ES Service Information

SI0082
New 4-04

Equipment Affected: YK Chillers

Software Enhancements Effective April 2004

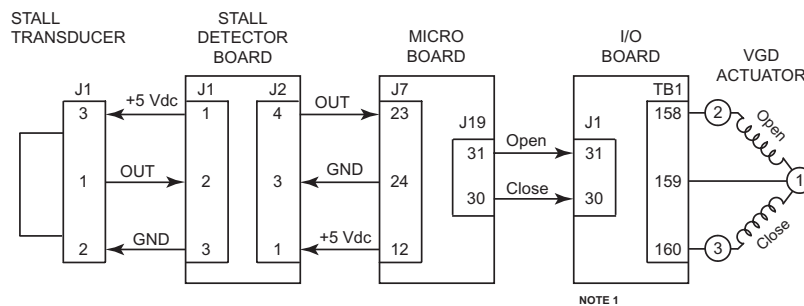
Beginning April 2004, enhanced software will be supplied in new production YK chillers. It is backward compatible to all previous YK chillers. The enhancements are outlined below.

The versions and part numbers for 031-01730-000 Microboards are:

- NEMA 1-4 chillers C.MLM.01.10.107 (p/n 031-01797-001)
- CE chillers C.MLM.01.10.208 (p/n 031-01797-002)

The versions and part numbers for 031-02430-000 Microboards are:

- NEMA 1-4 & CE chillers C.OPT.01.10.302 (p/n 031-02474-001)

FIG. 4

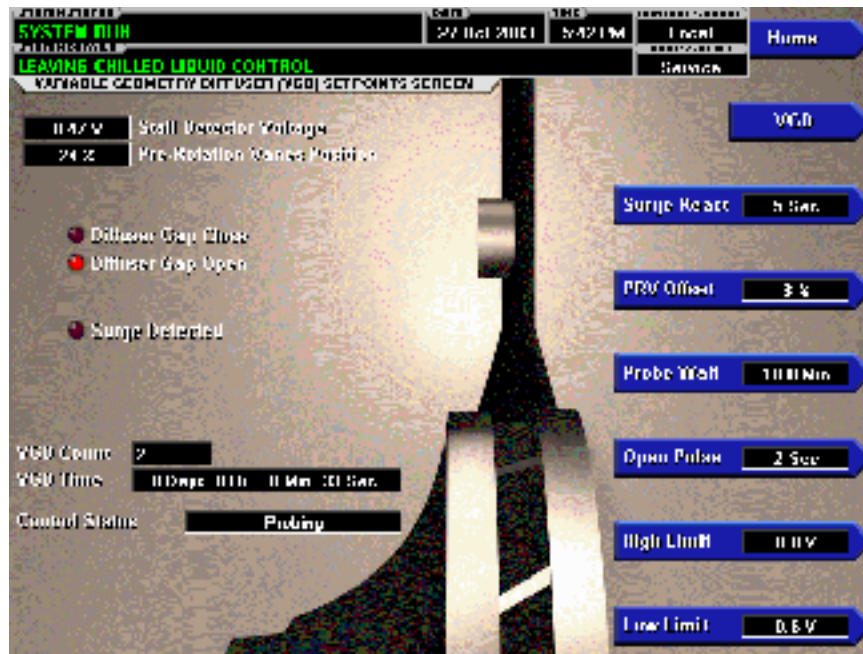
All setpoints relating to the VGD operation are maintained on this screen. Refer to Fig. 4.

The Variable Geometry Diffuser setpoints are maintained on this screen. All setpoints require a login access level of Service. Service Technicians refer to YORK Service Manual 160.54-M1 for operation and explanation of all setpoints and displayed values.
